HORSHAM DISTRICT COUNCIL CONSULTATION

TO:	Horsham District Council – Planning Dept
LOCATION:	Roundstone Park Worthing Road Southwater West Sussex
DESCRIPTION:	Application for Approval of Details Reserved by Conditions 10 & 16 to approved application DC/22/0096
REFERENCE:	DISC/24/0215
RECOMMENDATION:	No objection

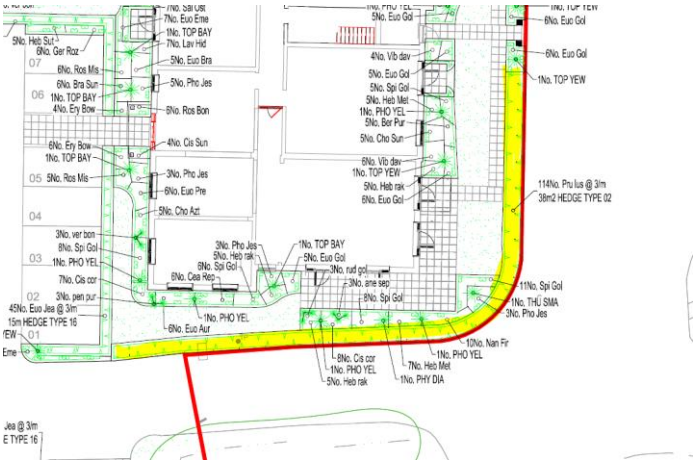
1. proposed trees are to be changed to 20-25cm girth semi-mature specimens (Acer & Tilia) along the western boundary facing the street and at the entrance of the development. Closed with thanks
2. all remaining proposed trees must be extra heavy standards (14-16cm) as a minimum girth size. Not addressed
3. Replace Pinus nigra with a more appropriate species for the residential location. Not addressed
4. It is recommended that hedge type 2 prunus lusitanica is changed to a native hedge, see mark up below – Closed with thanks
